**Re: San Roque & La Sorena  
441 & 457 Coors Blvd. NW  
Conceptual Traffic Circulation Layout for DFT Approval  
Engineer's Stamp 10-04-23 (J10-D049)**

**RE: SAN ROQUE & LA SERENA  
441 & 457 COORS BLVD. NW  
TRAFFIC CIRCULATION LAYOUT - RESPONSE TO COMMENT**

**Traffic Circulation Layout**  
**c5.0**

## c7.1

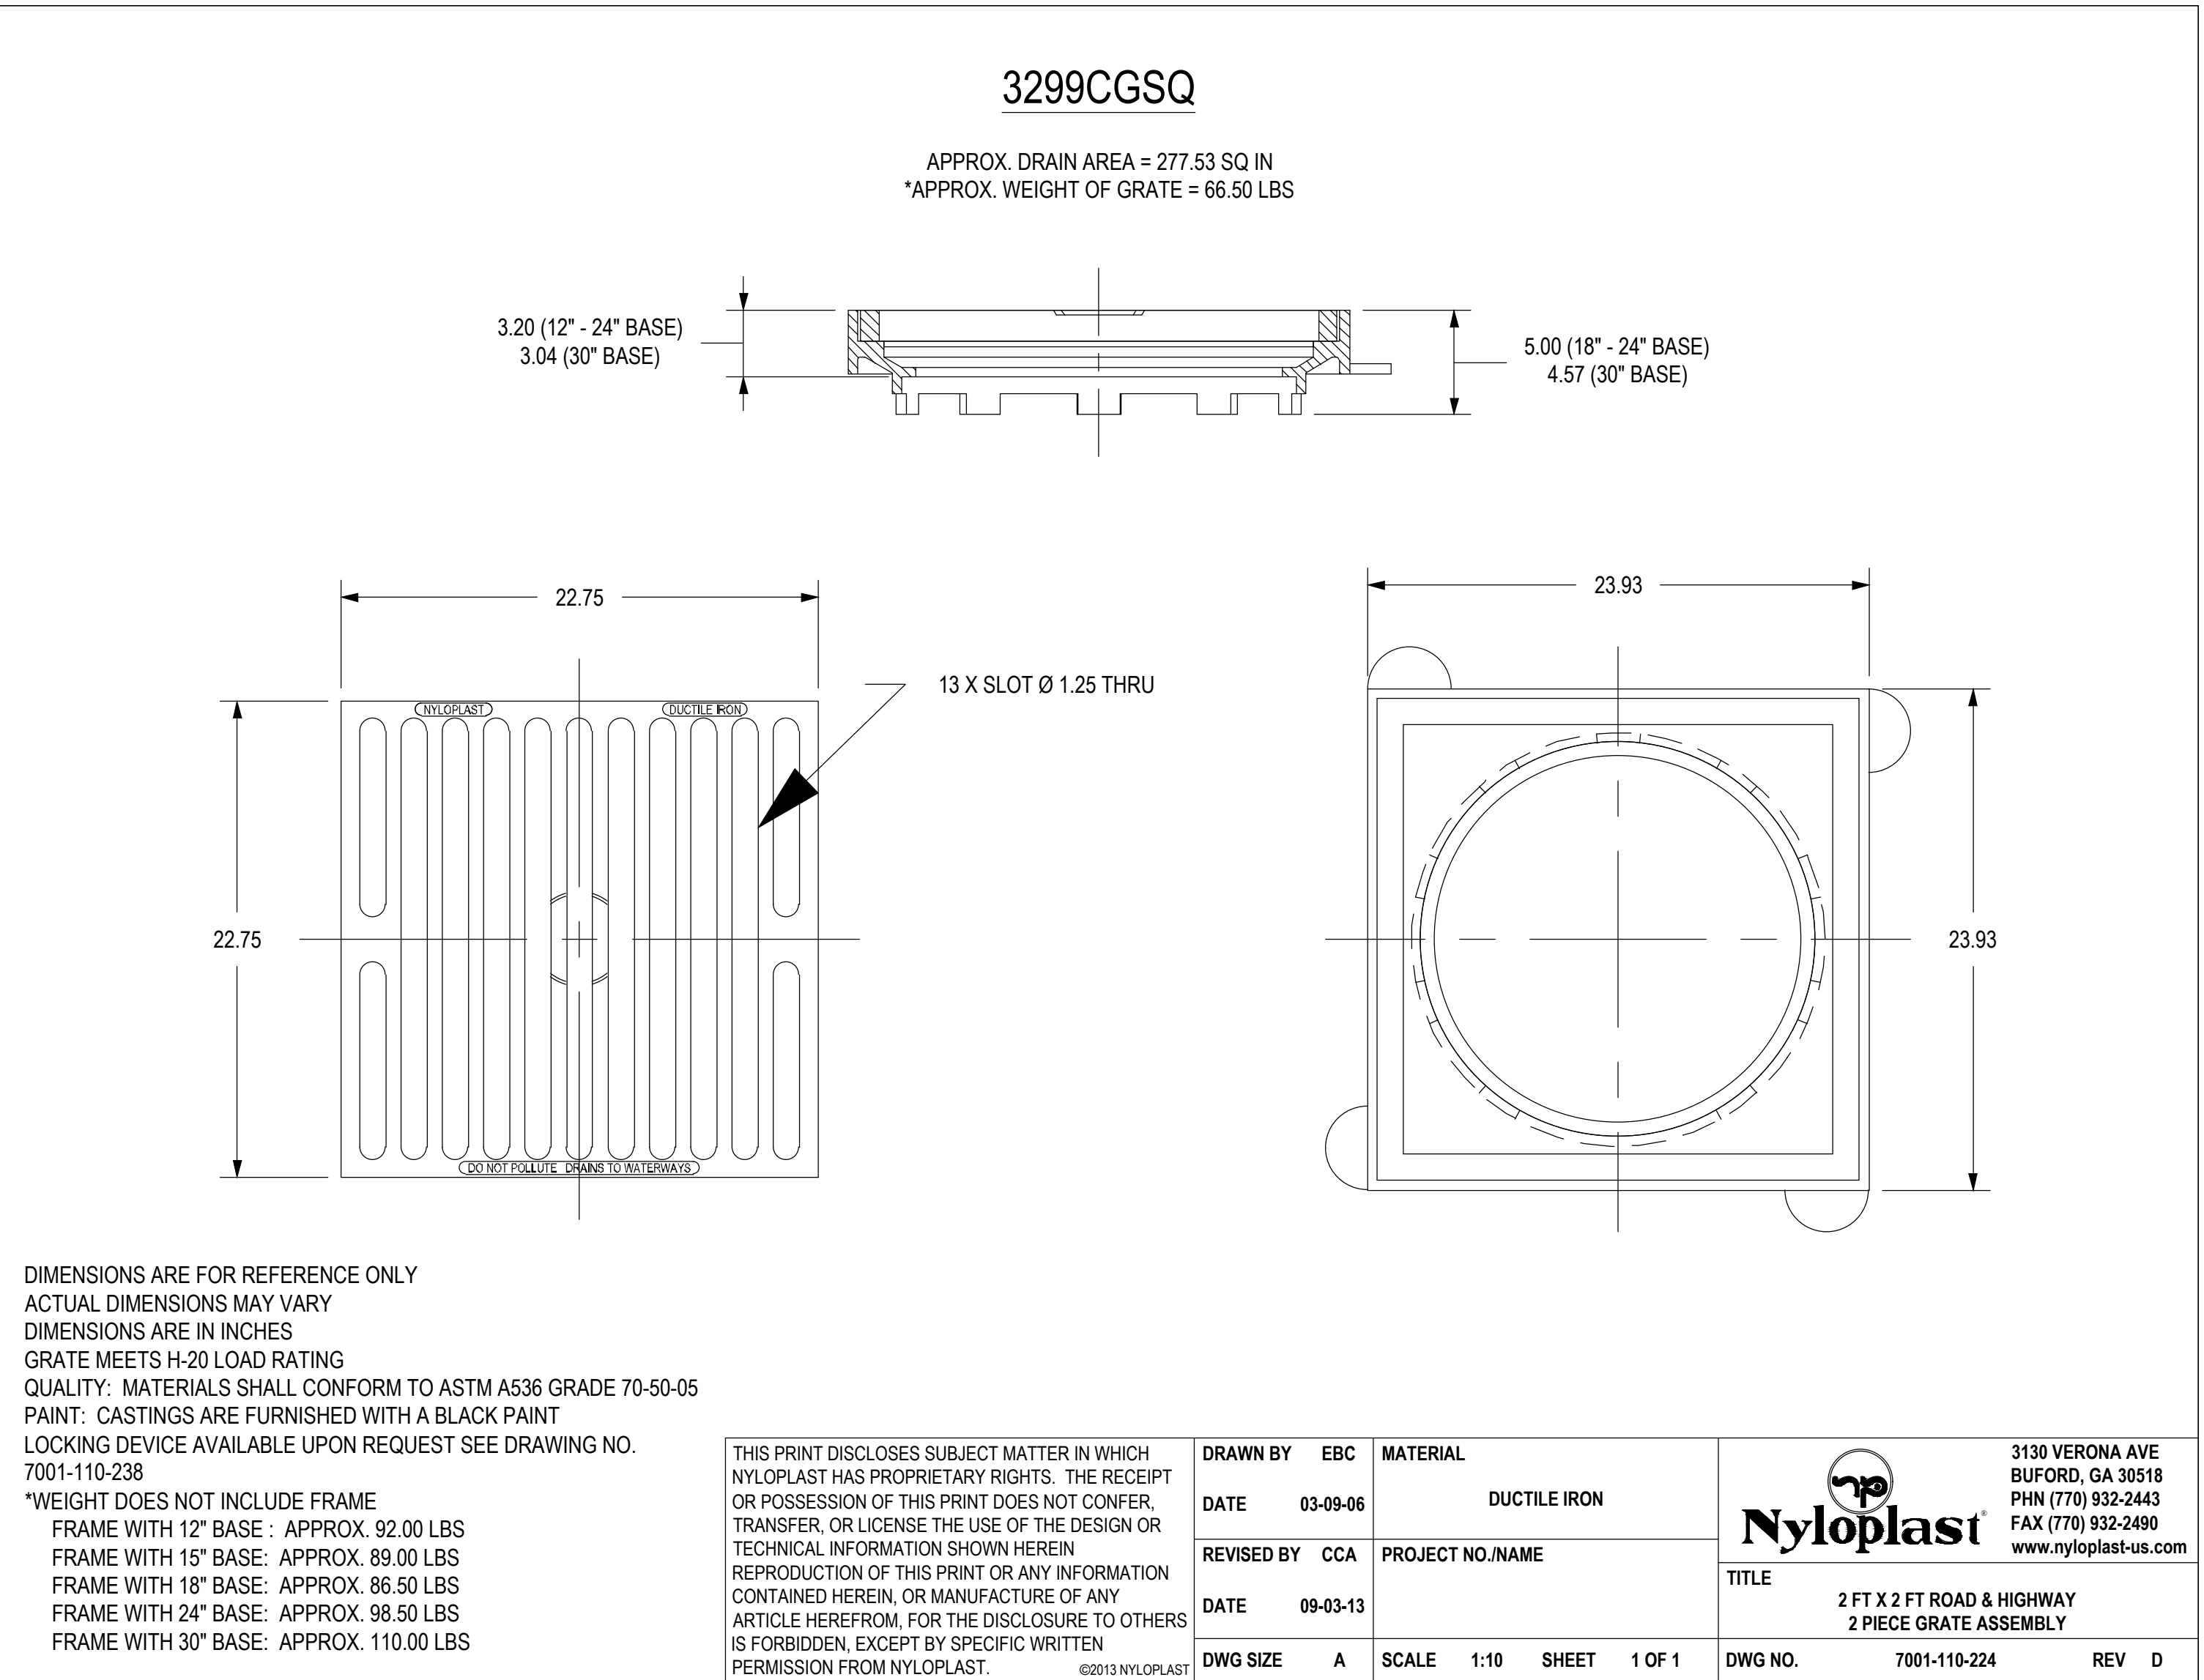
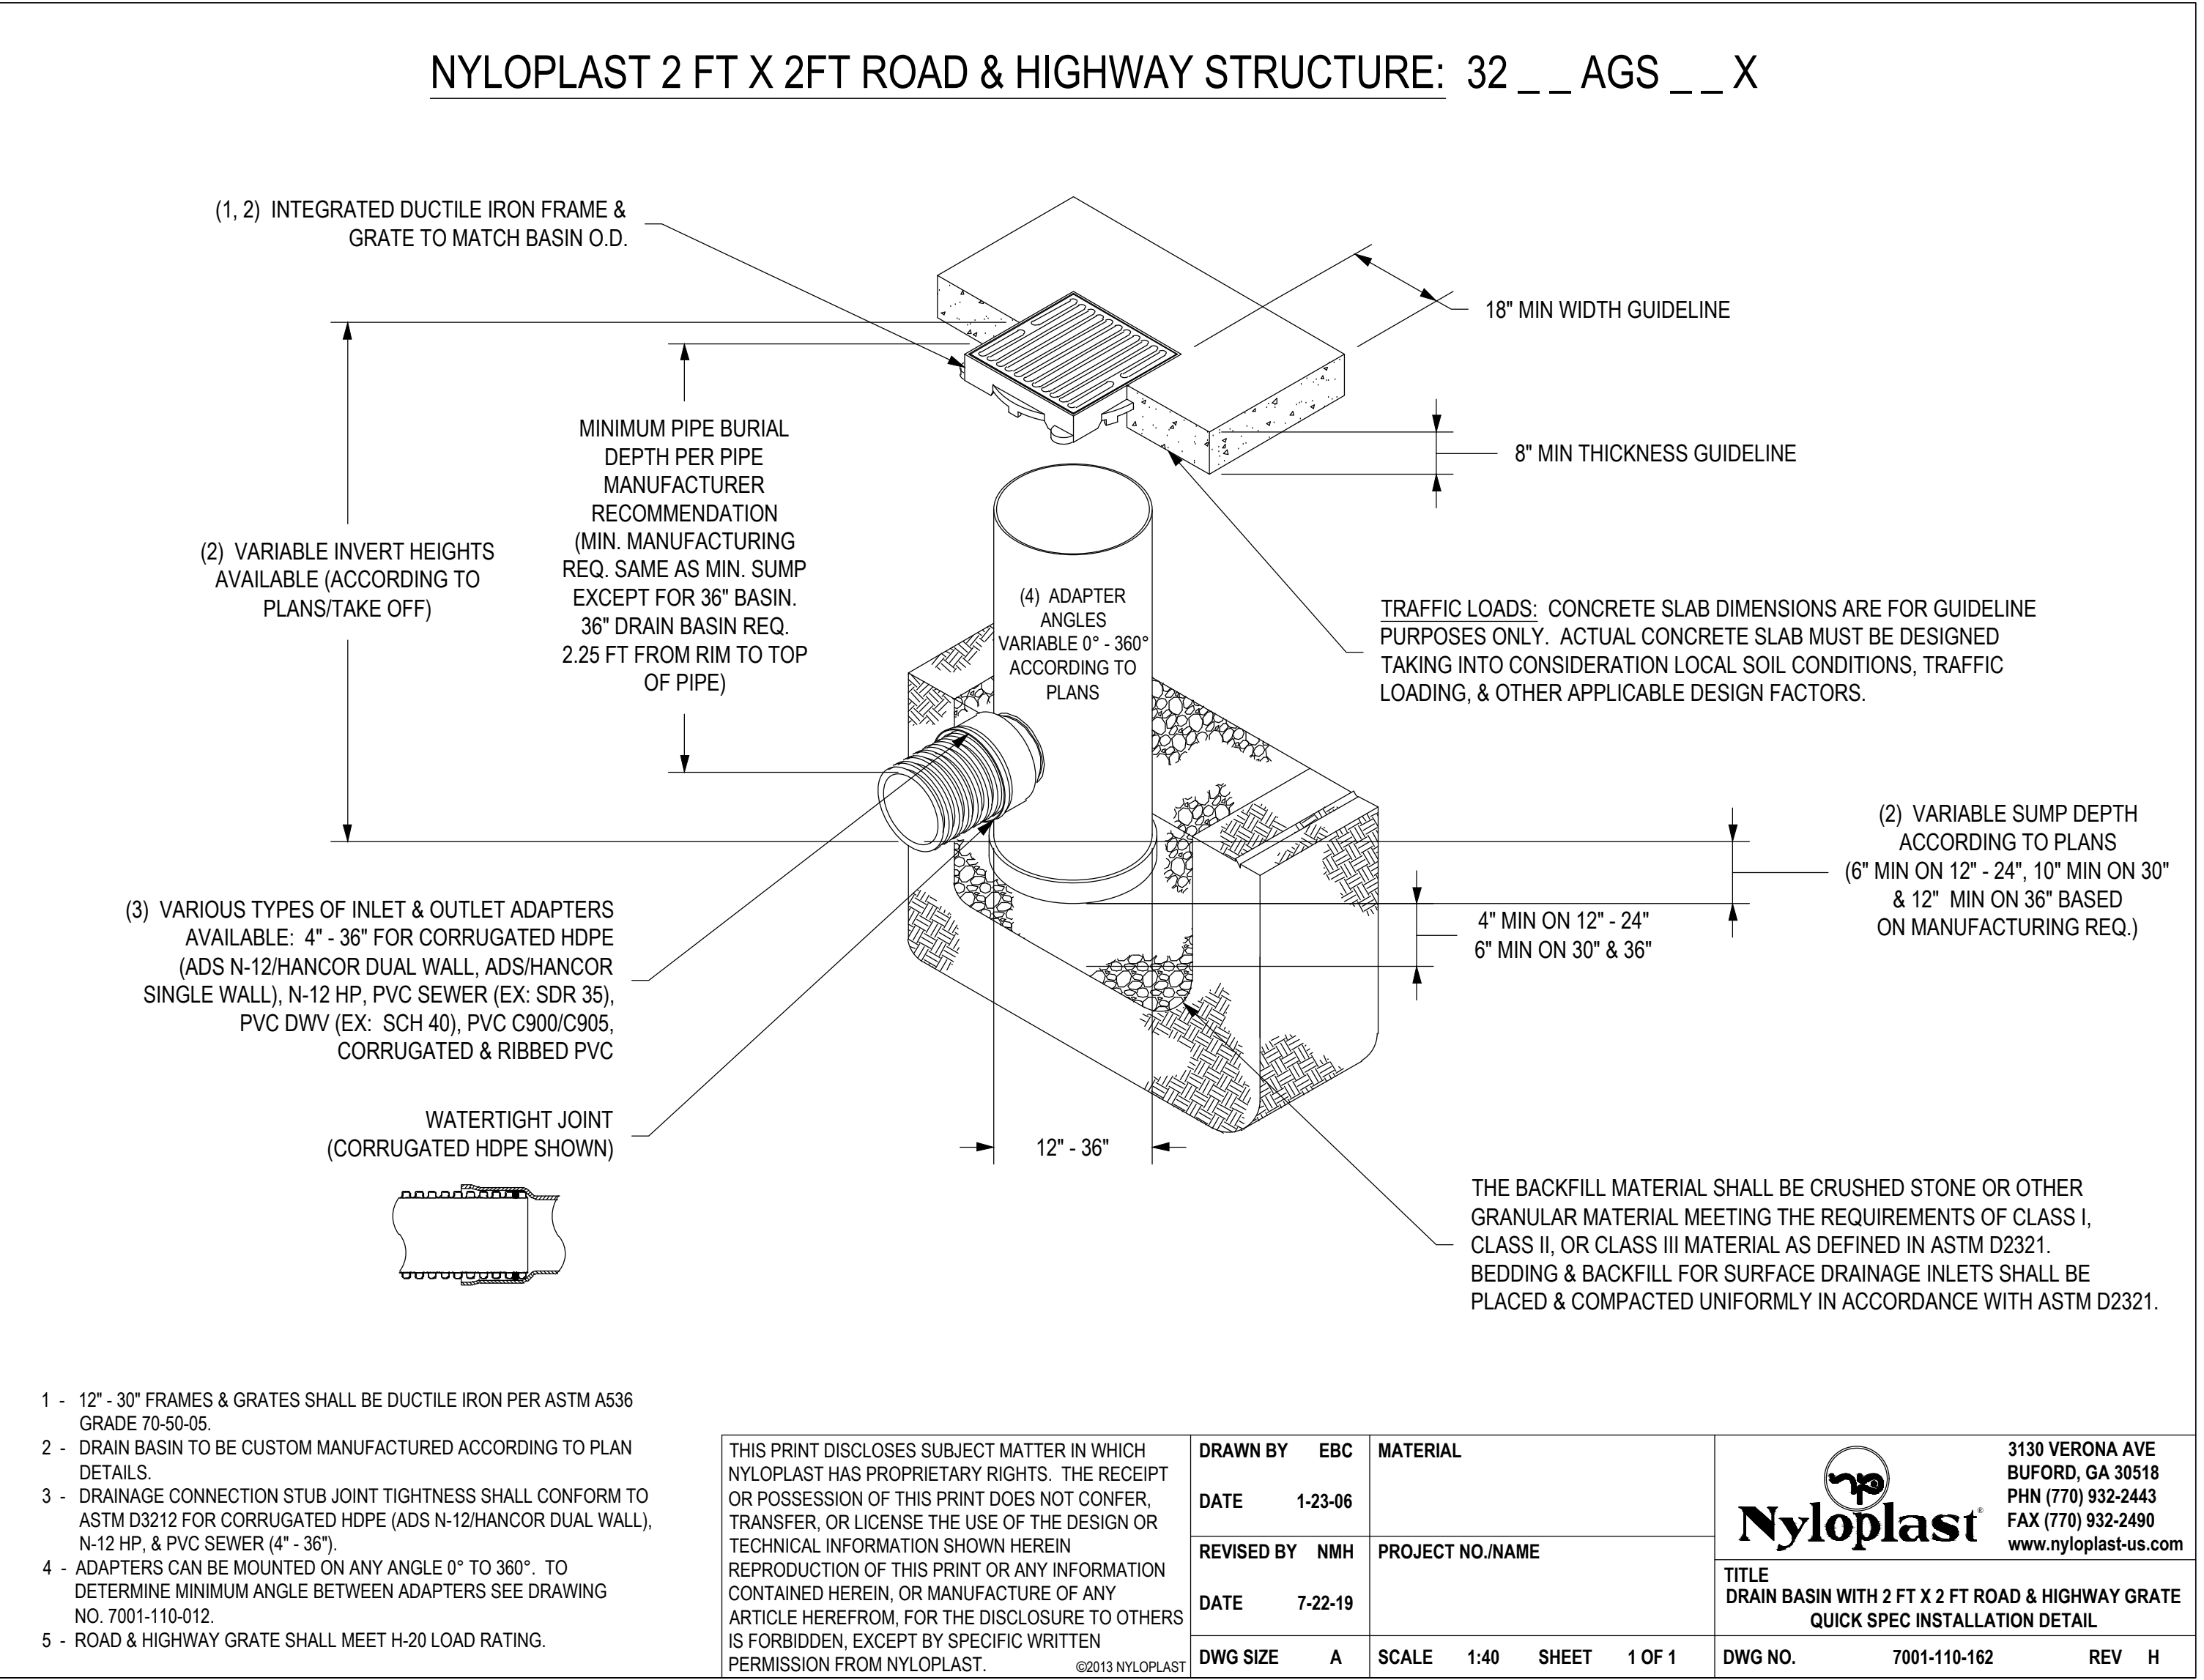
10. Please provide Bike Rack details. Details sheet C7.0 and C7.1 are missing.

11. All bicycle racks shall be designed according to the following guidelines:

**Response: Bike Rack details are shown on Sheet C7.0, which is now included in this resubmittal.**

**Response: The bicycle rack detail on sheet C7.0 meets all of these requirements.**
